SERVICE BULLETIN

TITLE: FUSELAGE - INSPECTION/INSTALLATION OF RH FUSELAGE MISSING RIVETS

This service bulletin has been revised and is produced in the new format for Raytheon Aircraft Company service bulletins. Relevant technical changes are marked with change bars in the outside margins. Changes have been made to add Model 36, Model A36TC, and 58A listings to the Effectivity to pair these models with appropriate Serial Numbers, which were not accurately defined in the original issuance or Revision 1 of the Service Bulletin. The Compliance statement has been changed to reference the Airworthiness Directive.

Inspection/Installation of Missing Rivets in RH Fuselage
Figure 1

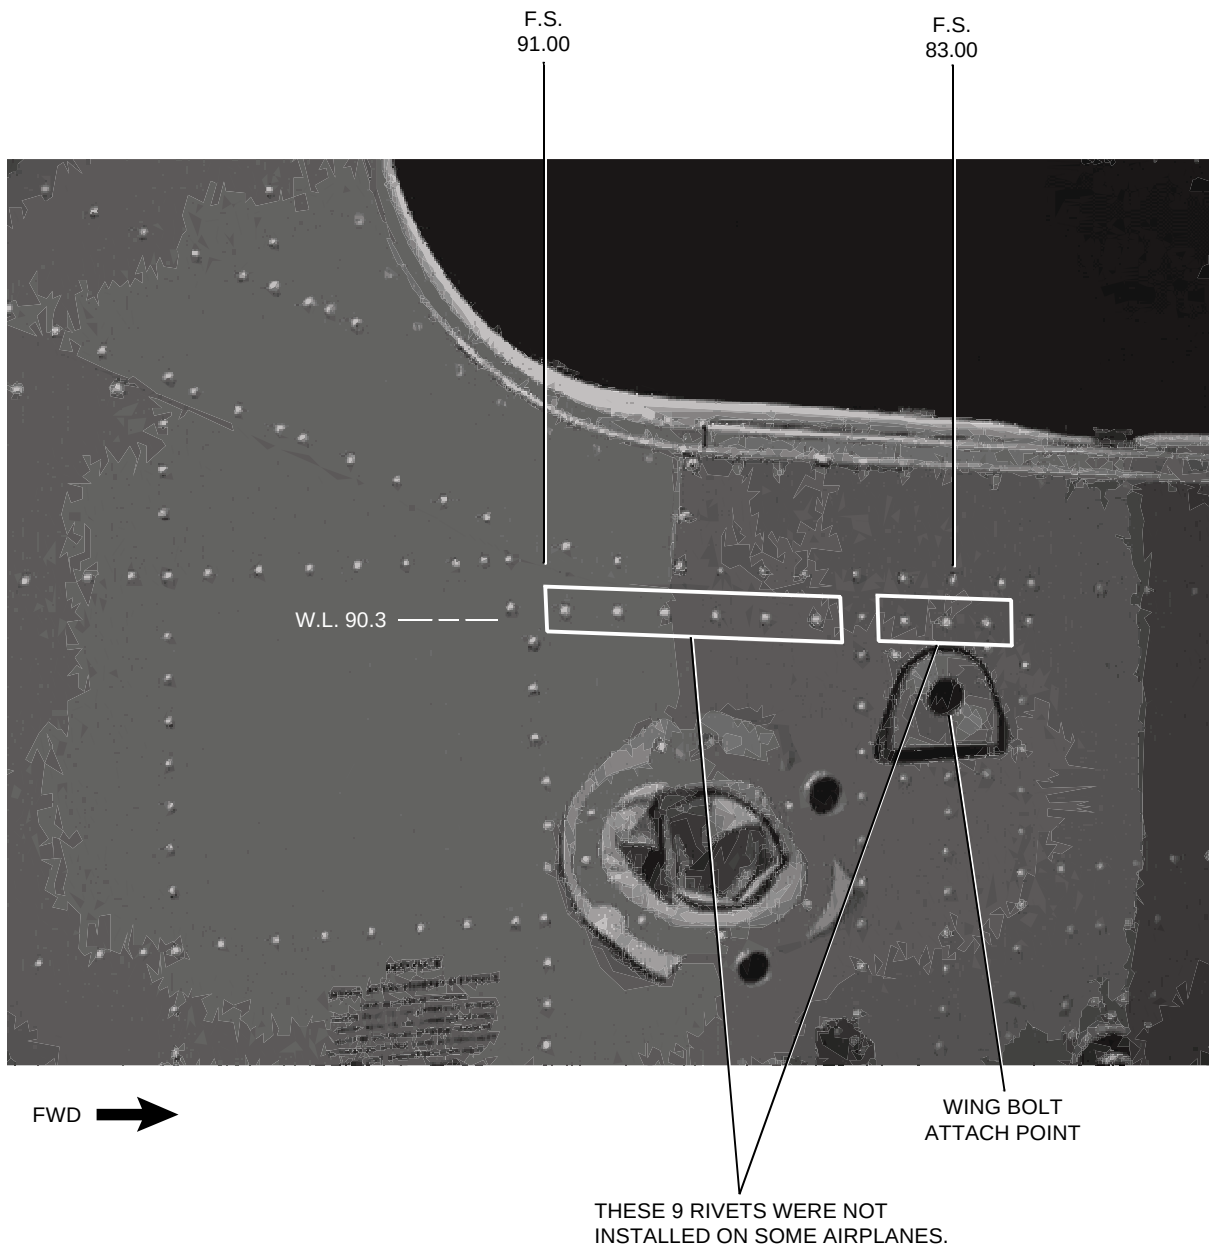
- (1) Refer to Figure 1 and inspect for rivets between F.S. 83.00 and F.S. 91.00 at W.L. 90.3. Universal (round) head or flush head blind rivets may have been installed along this rivet line. If rivets are installed in the noted locations, no further action is necessary. If rivets are not present, proceed to step 2.
- (2) Remove all power from the airplane and disconnect the battery. Display warning notices prohibiting reconnection of airplane electrical power.
- (3) Open cabin or passenger door to gain access to airplane interior. Refer to airplane Maintenance Manual.
- (4) Remove passenger seats, as required, to gain access to the RH Side Panel. Refer to airplane Maintenance Manual.
- (5) Remove RH Side Panel.
- (6) Remove and retain interior insulation from areas above the floorboards and between the forward and aft spars, 9.70 inches below W.L. 100.00 (approximately W.L. 90.3).

- (8) Drill pilot holes for missing P/N MS20470AD4-X or equivalent rivets in locations as follows (see Figures 1 and 2):
 - (a) Drill three holes through the skin and P/N 002-430043-19 gusset just above the upper wing bolt attach fitting cutout.
 - (b) Drill six holes through the skin and the edge of the P/N 002-430043-19 gusset just aft of the aft web flange on the front spar.
- (9) Drill 0.125 + 0.0035 inch diameter holes for installation of P/N MS20470AD4-X or equivalent rivets.

- (13) Refer to Figure 1 and Figure 2 and install P/N MS20470AD4-X or equivalent rivets in hole locations drilled in step 9. Dip each rivet shank in epoxy polyamide primer and install wet. Use an appropriate size rivet gun and bucking bar to install rivets.
